**TOWN OF ACTON
DESIGN REVIEW BOARD
Review Memorandum:
South Acton Vision Plan Review**

February 29, 2024
In-Person Meeting

Documents Reviewed:

A Powerpoint presentation of the South Acton Vision Plan, a document entitled: “Amend Zoning Bylaw and Zoning Map South Acton Village District” (attached).

Example of pedestrian plaza and building fronts.

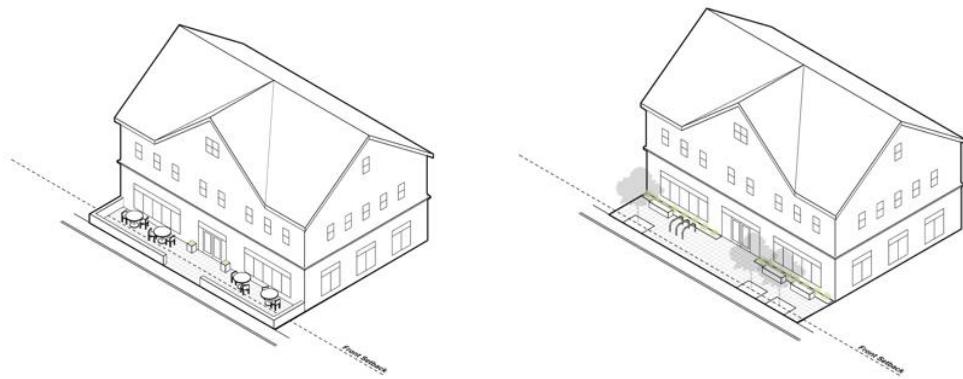
- a. BUILDING facades facing STREETS are also referred to herein as building fronts or building front facades.
- b. The entire front side of a LOT facing a STREET shall be occupied by BUILDINGS or by a pedestrian plaza that are located within the 10-foot maximum setback, with the exception of sidewalks, walkways and the minimum allowed width for an access drives. Pedestrian plazas shall be a natural gathering spot at the STREET level in front of a BUILDING, on the side of a BUILDING, in between BUILDINGS, which is to be used exclusively by pedestrians and connects to the sidewalk and walkways. Pedestrian plazas may be utilized for outdoor dining.
